3/4.11 RADIOACTIVE EFFLUENTS

Significant Hazards Consideration

The proposed separation of Technical Specification Figure 5.1.1-1, into Figure 5.1.1-1a and 5.1.1-1b, and the revision of the appropriate sections of the Technical Specifications which refer to these figures, are clarifications to the geographical areas utilized when computing dose calculations resulting from liquid and gaseous effluents. This change is requested to resolve the inconsistency between the Technical Specification and the licensing basis in the Updated Safety Analysis Report (USAR) along with the guidance given by the NRC in NUREG-0133 "Preparation of Radiological Effluent Technical Specifications for Nuclear Power Plants". This change does not affect any plant systems, nor could it affect possible initiating events for accidents previously evaluated, or any system functional requirements. Additionally, the proposed changes have no effect on accident conditions or assumptions. Based upon the above, the proposed change could not increase the probability or consequences of any accident previously evaluated.

FIGURE 5.1.1-1

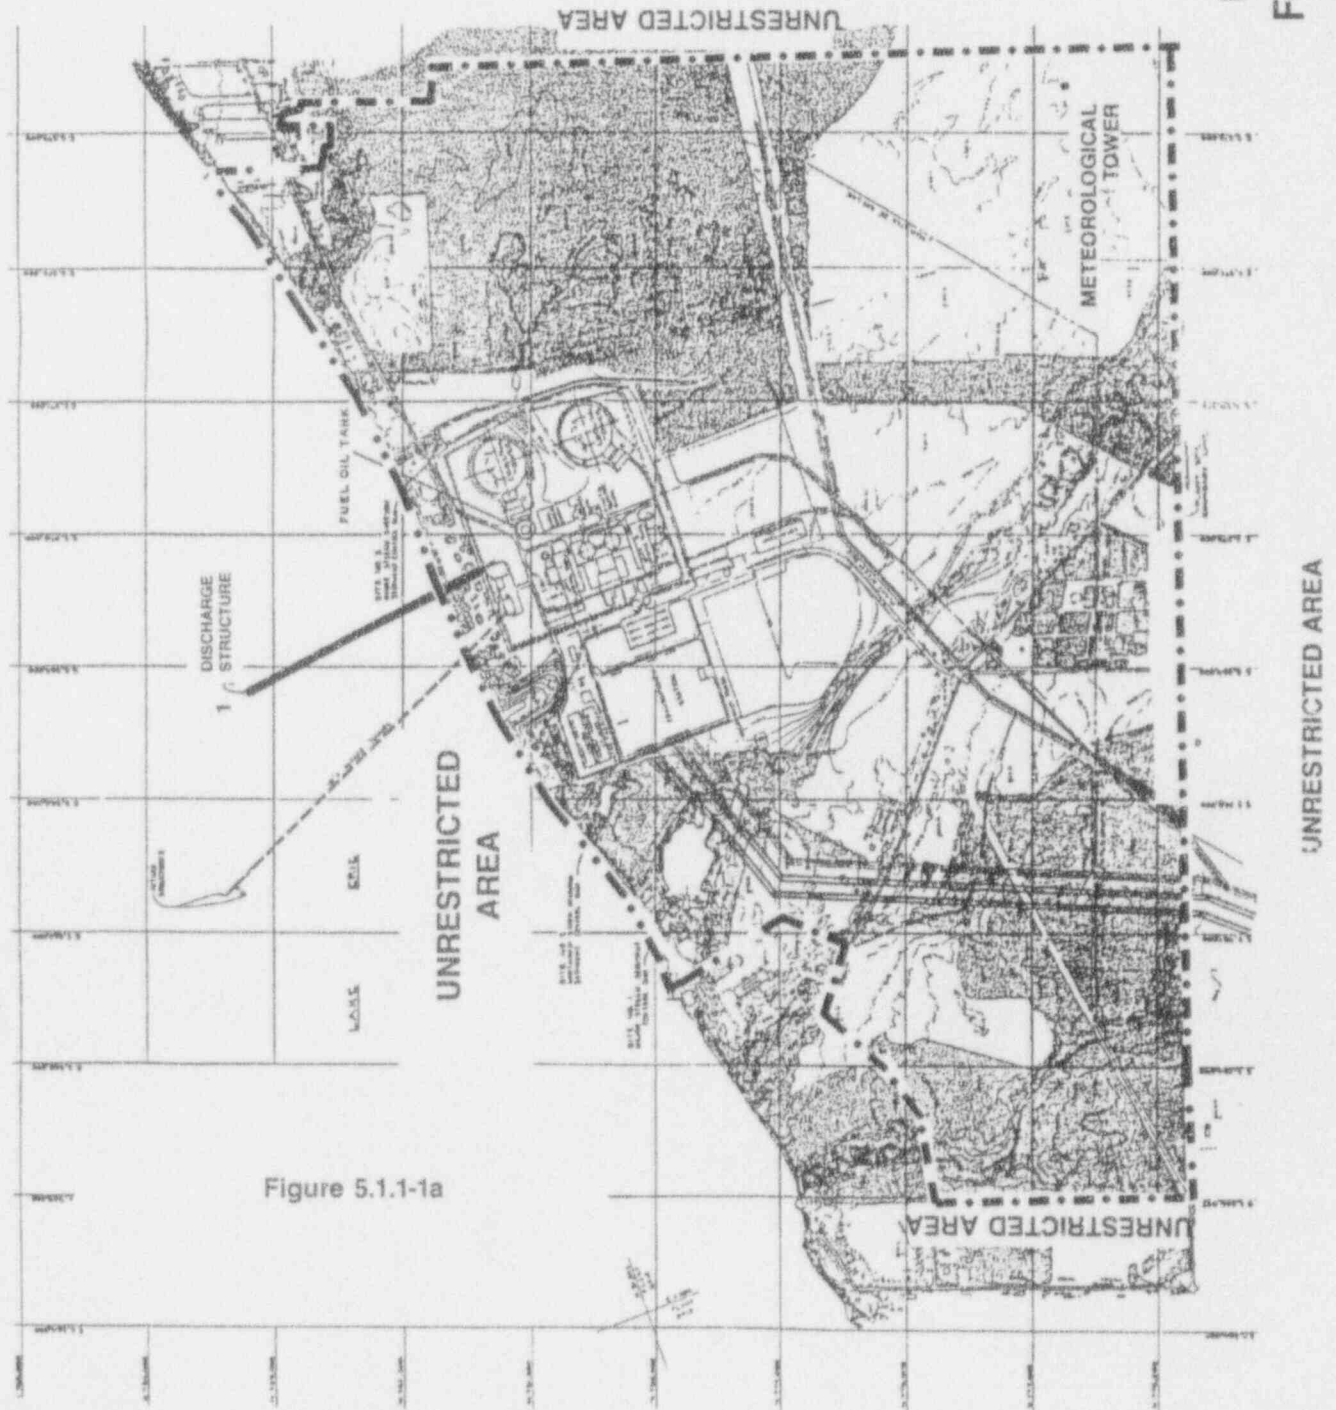
Figures 5.1.1-1a and 5.1.1-1b also show the liquid and gaseous effluent discharge locations as well as the plant SITE BOUNDARY for gaseous releases and the UNRESTRICTED AREA for liquid effluent releases. The dose rate and doses due to radioactive materials released in gaseous effluents from the site to areas at and beyond the SITE BOUNDARY shall be limited pursuant to Specification 3.11.2.1, 3.11.2.2, and 3.11.2.3. All gaseous effluent releases at PNPP are considered to be ground-level releases. The concentrations of radioactive materials released in liquid effluents to UNRESTRICTED AREAS shall be limited pursuant to Specification 3.11.1.1.
